BVH ARCHITECTURE

ADDENDUM NO.: #01

DATE: 01/31/2024

PROJECT: Woodhouse Ford Pro: Building Improvements

1 DEMOLITION FLOOR PLAN - PLUMBING - AREA C
1/8" = 1'-0"

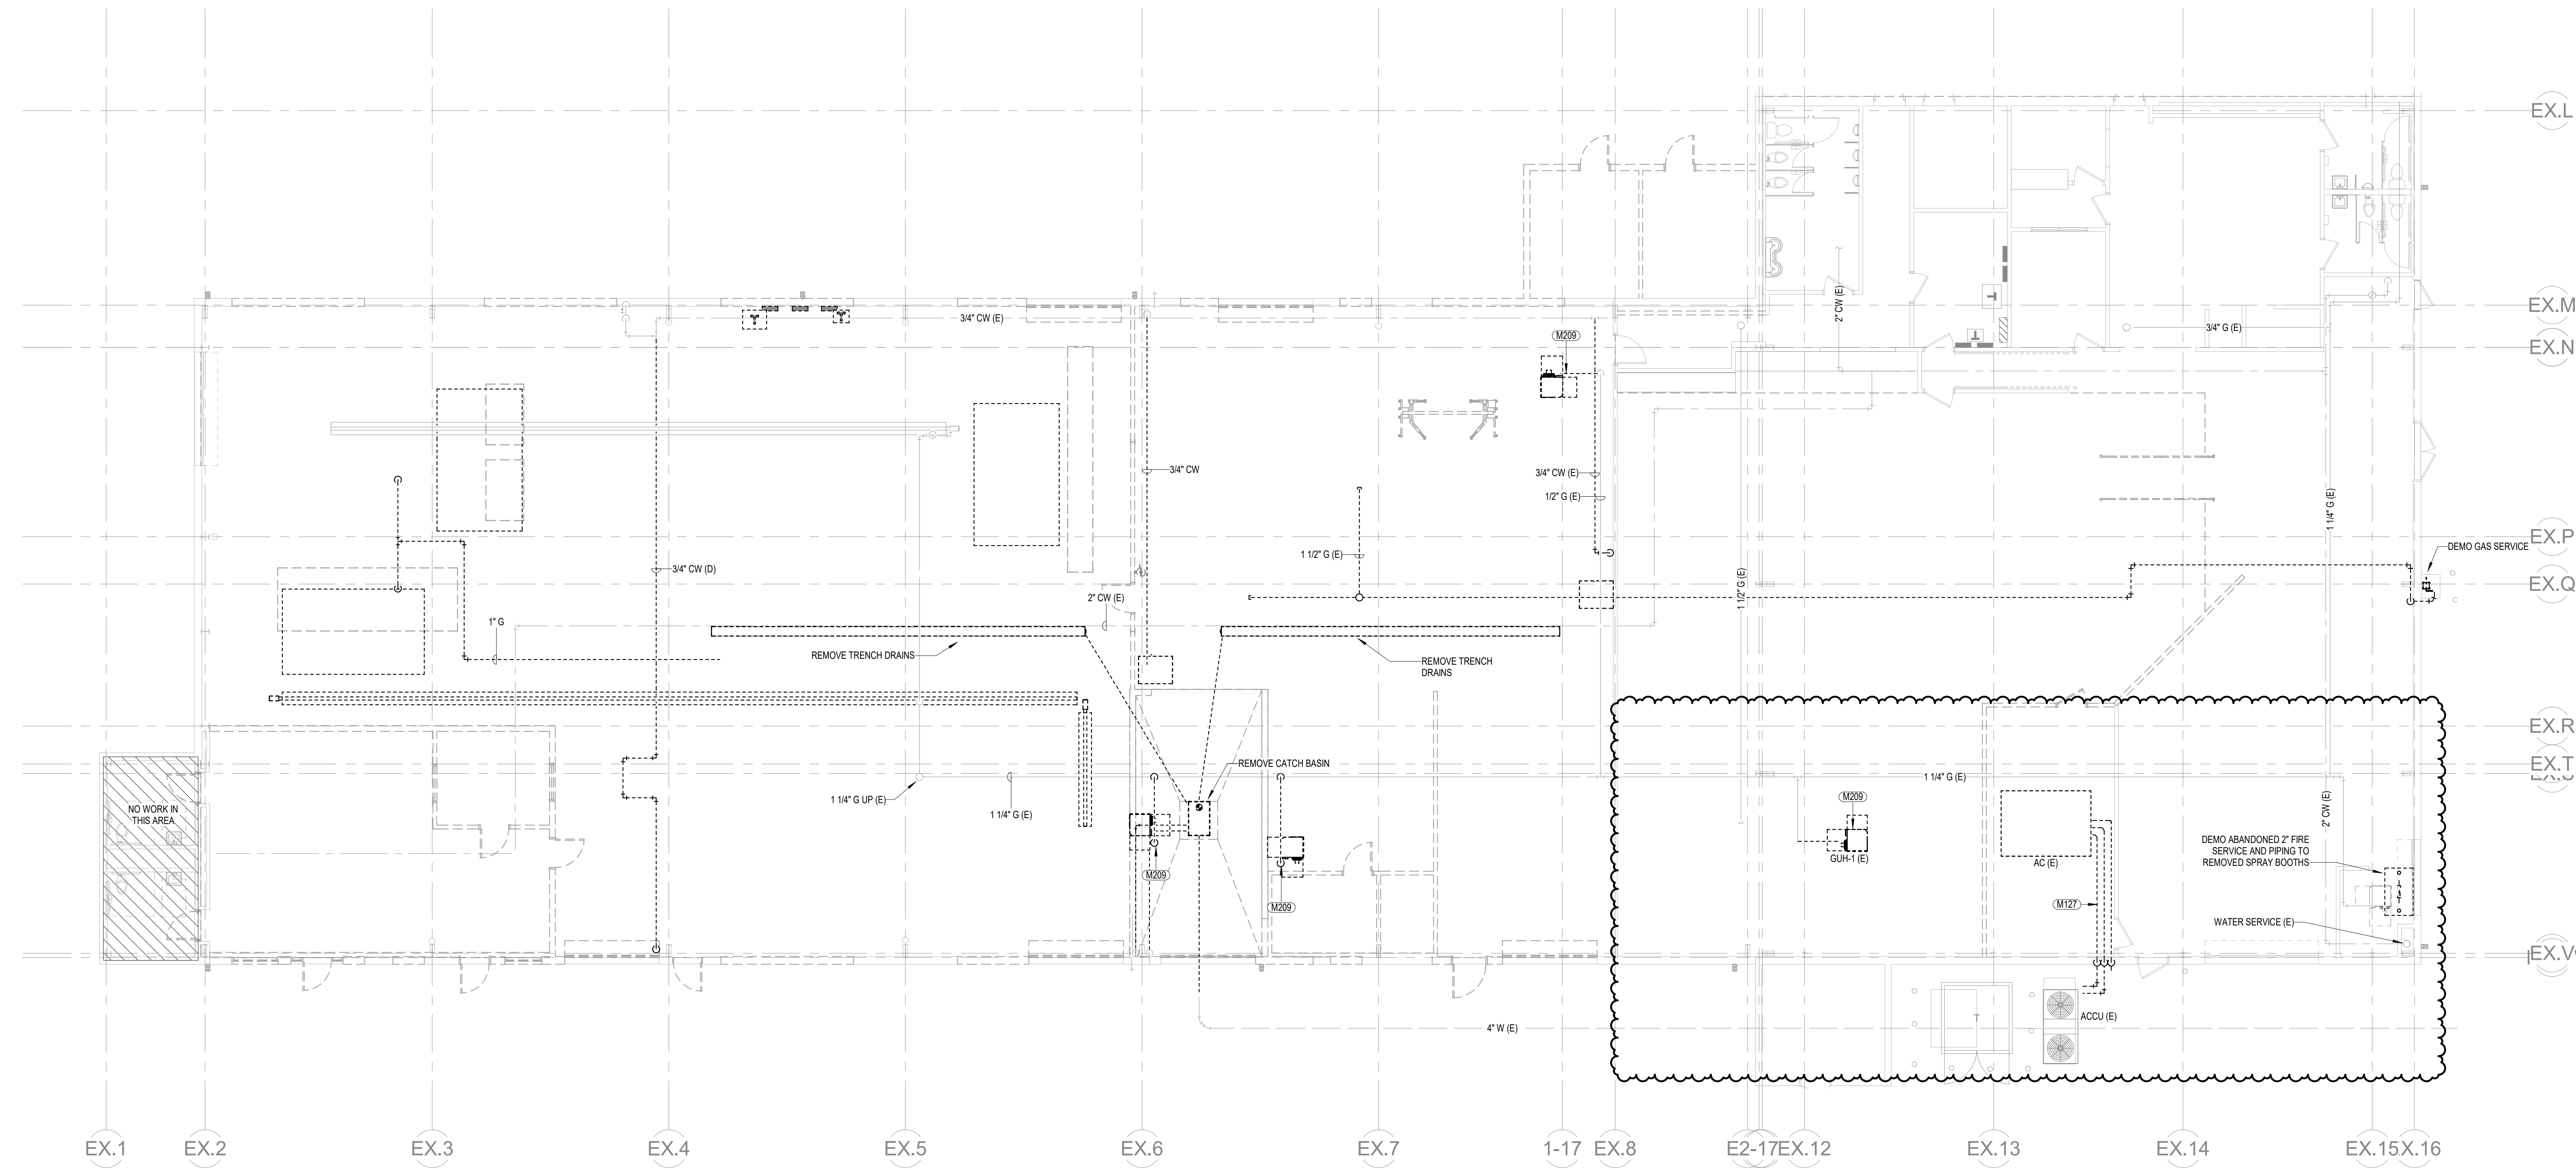
3. Sheet MD2.3 – DEMOLITION FLOOR PLAN – PLUMBING – AREA C
 - a. Demolish abandoned fire service serving old spray booths.
 - b. Demo refrigerant and condensate piping for relocated ac unit.

- c. Demo gas piping required for salvaged unit heater.
4. Sheet M1.3 – FLOOR PLAN – HVAC – AREA C
 - a. Relocate AC unit and unit heater. Provide new refrigerant piping for AC unit and gas piping for unit heater.

1 FLOOR PLAN - HVAC - AREA C
 1/8" = 1'-0"

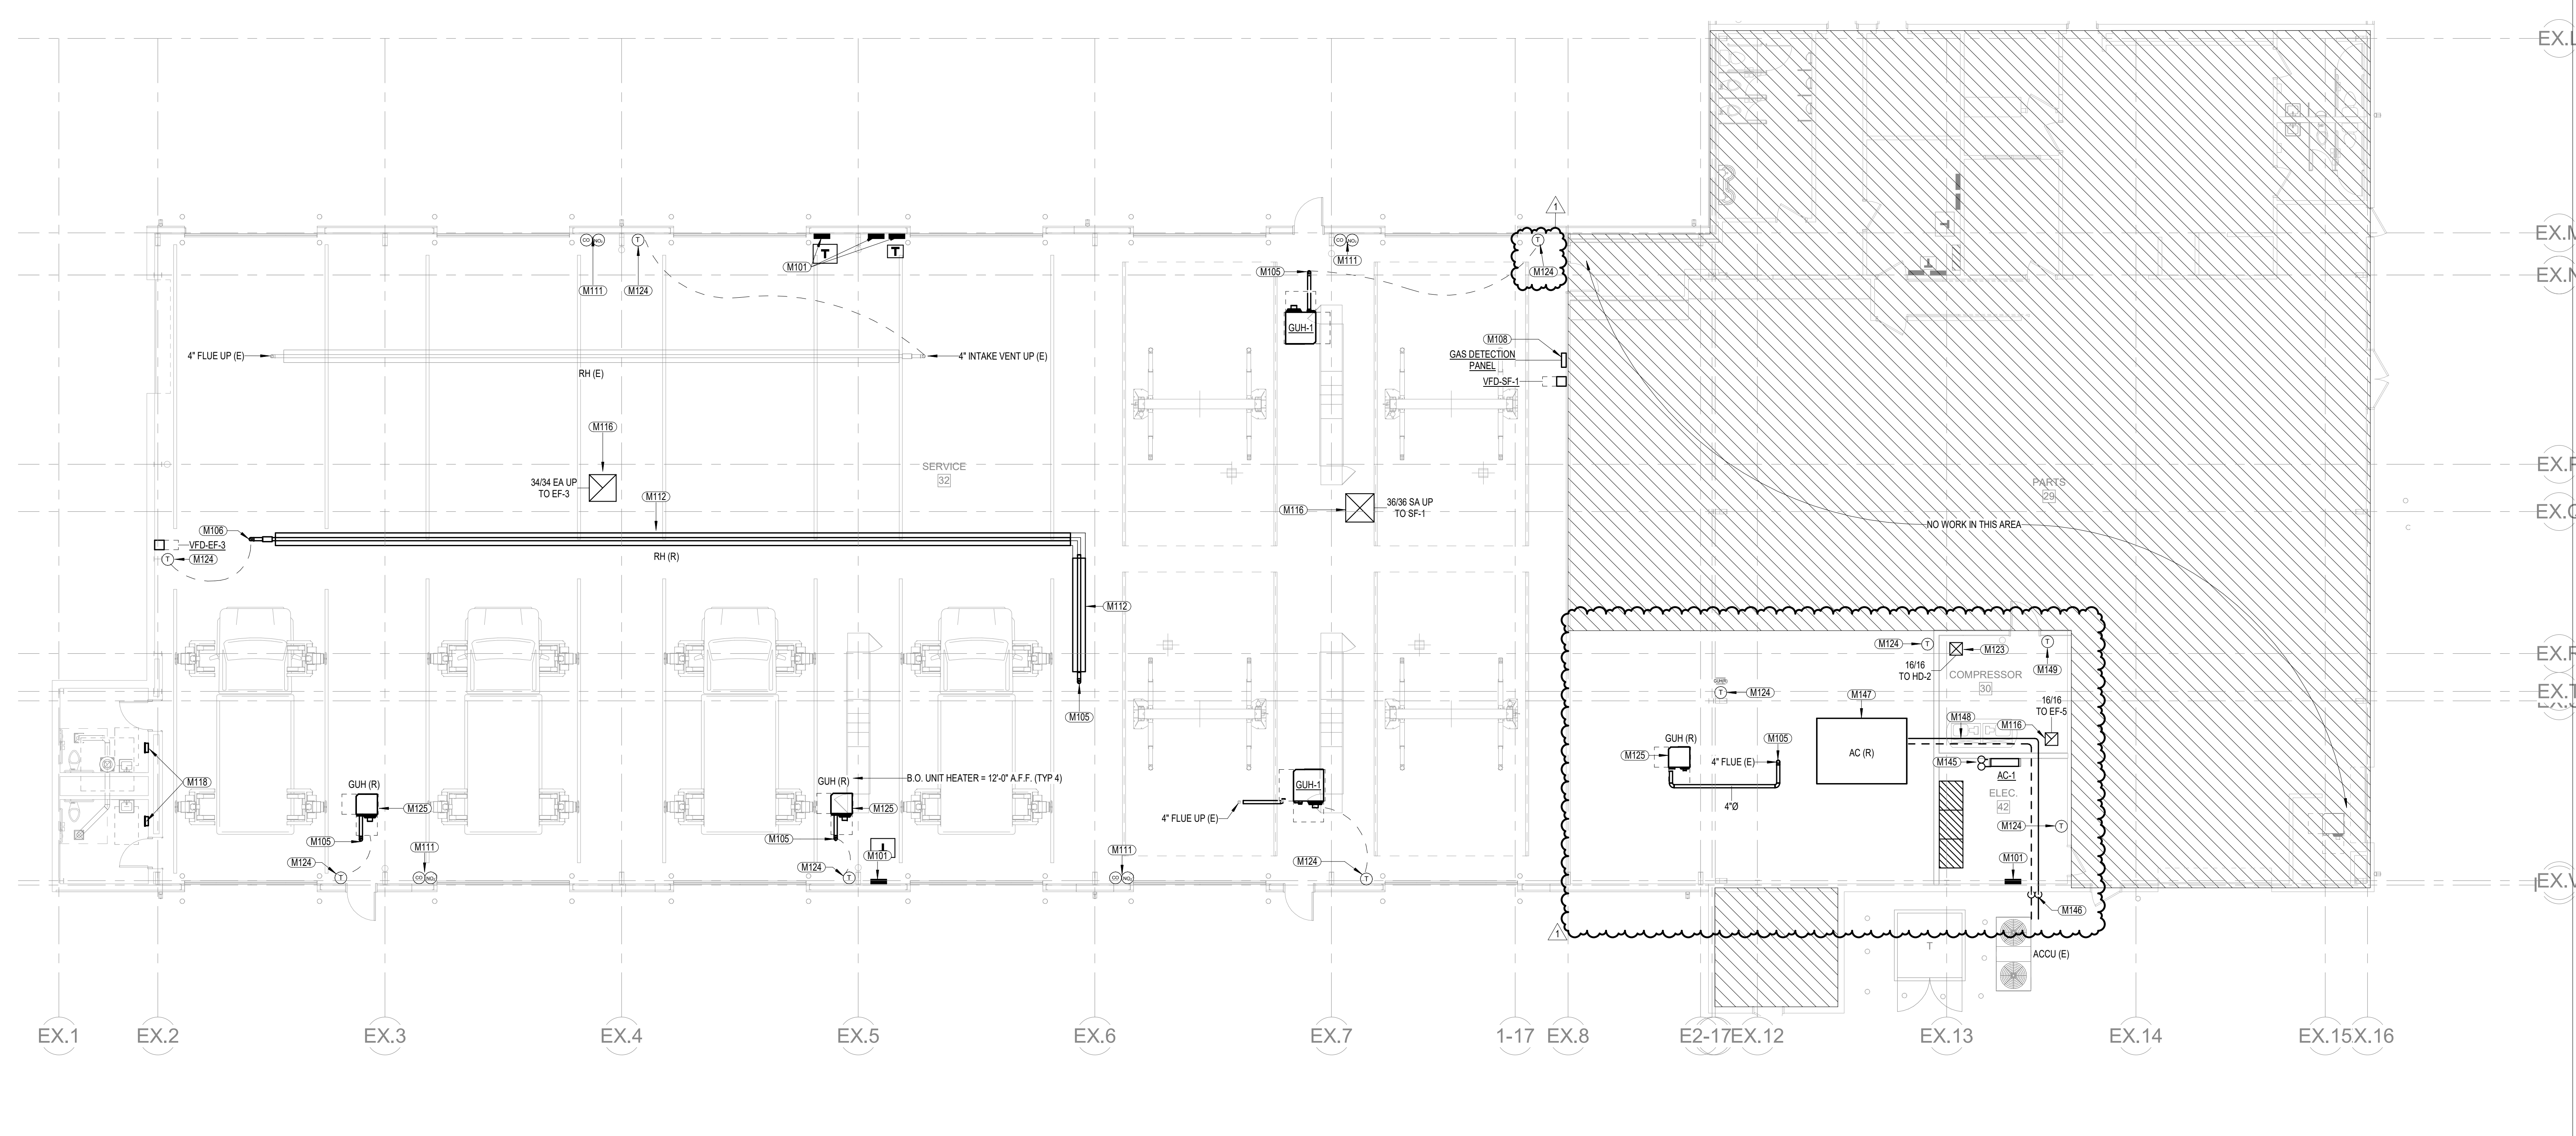
- b. Provide new thermostats for AC unit and unit heater.
 - c. Add split system wall mounted unit to condition Elec 42. Add associated refrigerant piping and thermostat.

- d. Revise thermostat for compressor room to be cooling only thermostat.
 - e. Provide new thermostat in Service 32 previously shown as existing.
5. Sheet M1.6 – ROOF PLAN – MECHANICAL – AREA C

- M149 PROVIDE COOLING ONLY THERMOSTAT FOR COMPRESSOR ROOM EXHAUST FAN. INTERLOCK OPERATION WITH EXHAUST FAN TO RUN WHEN THE ROOM TEMPERATURE RISES ABOVE 55°F (SEE FAN).

1 ROOF PLAN - MECHANICAL - AREA C
 1/8" = 1'-0"

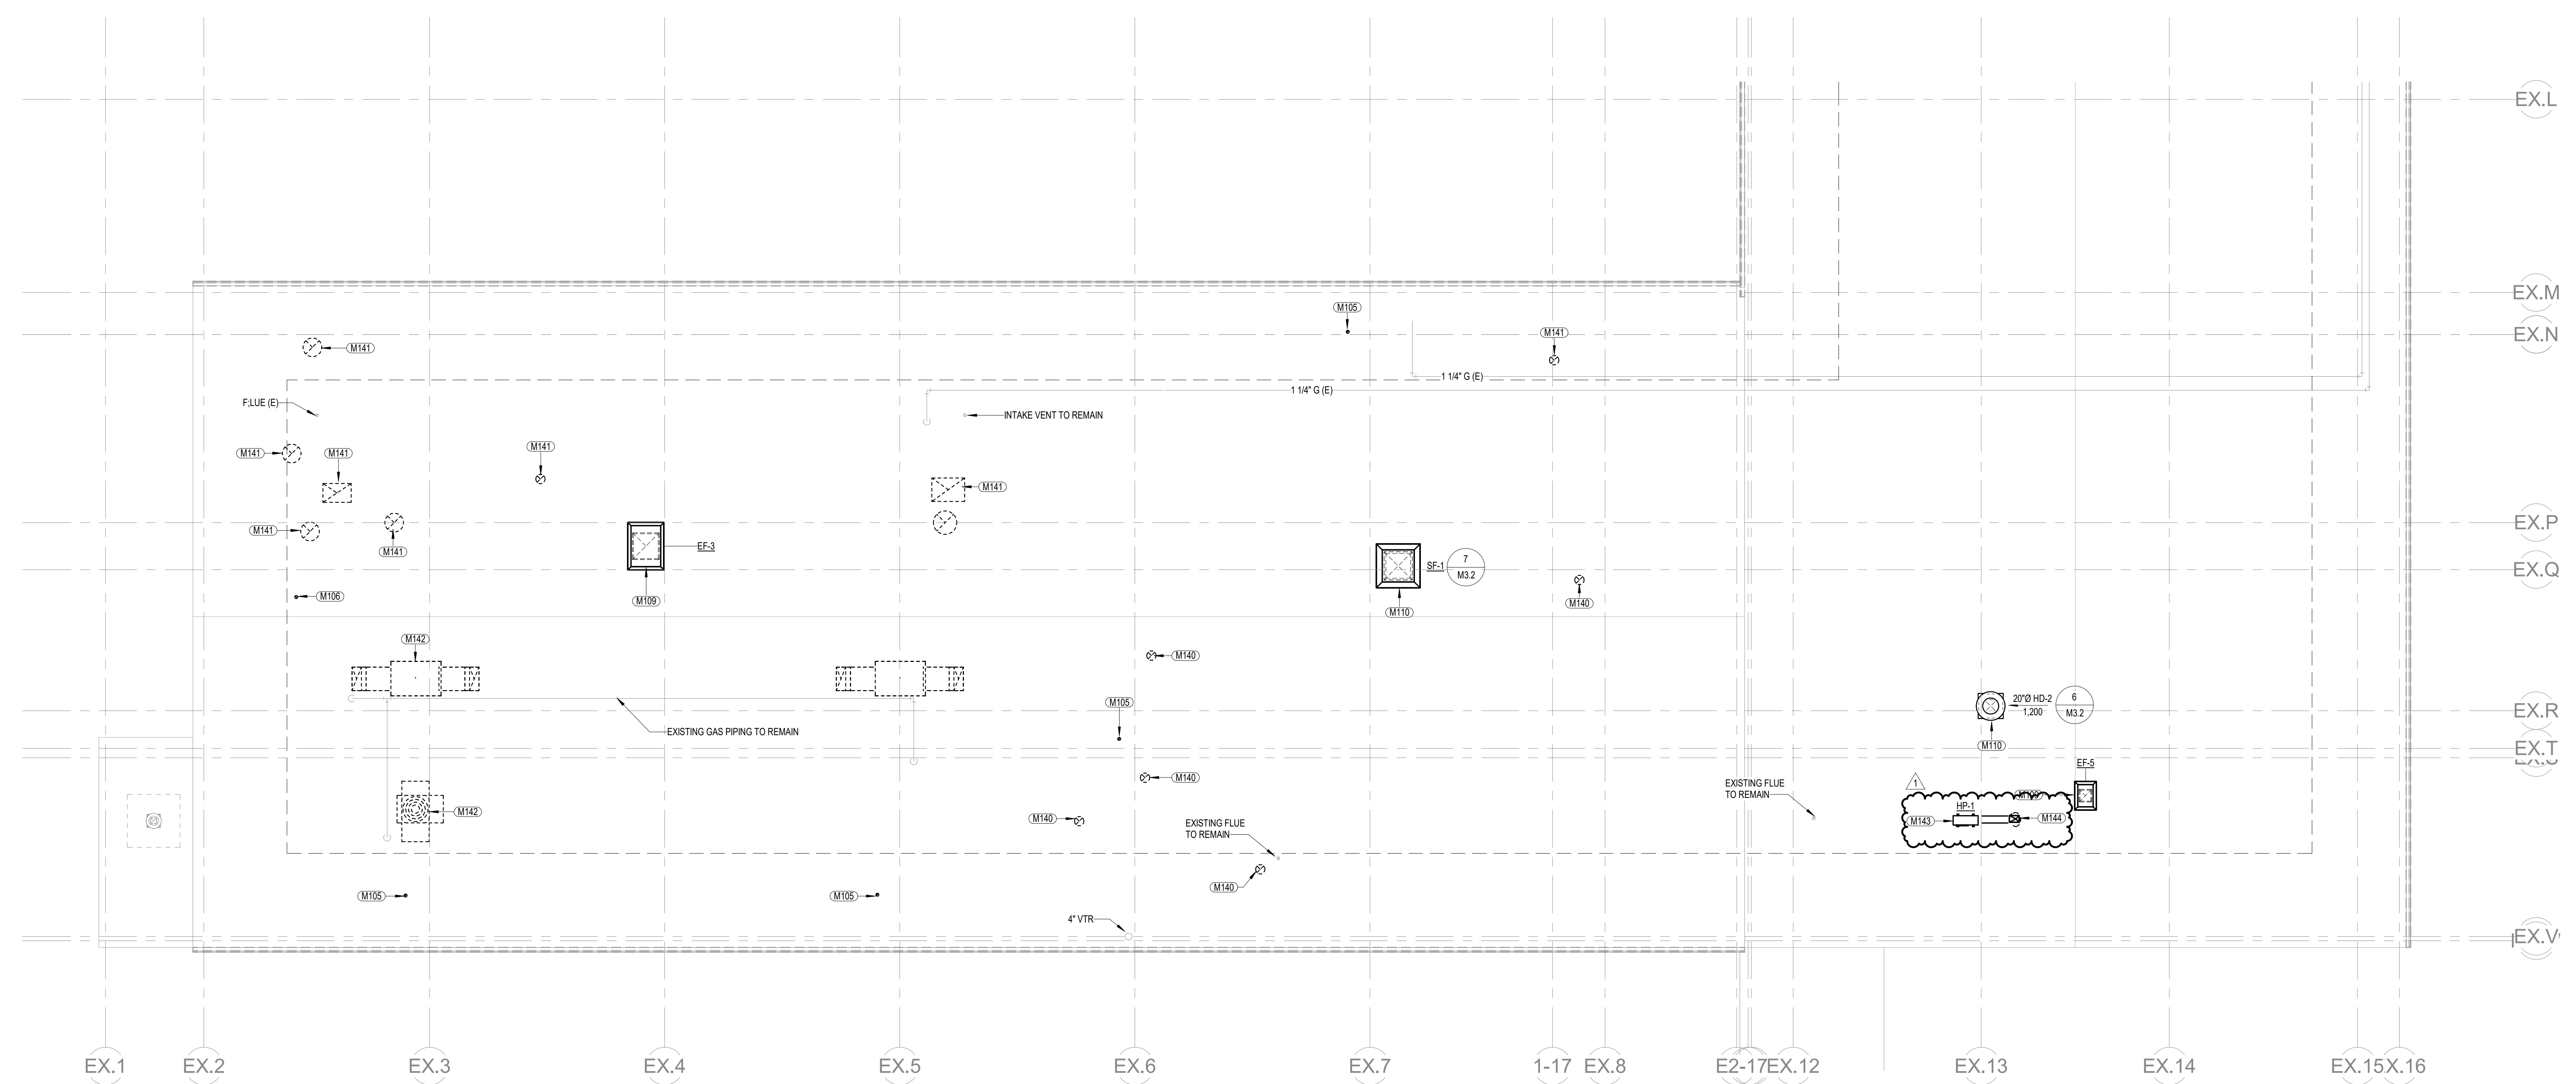
- a. Add refrigerant piping hood and air cooled heat pump unit for new indoor unit serving Elec 42.
6. Sheet M2.3 – UNDERGROUND PLAN – PLUMBING – AREA C
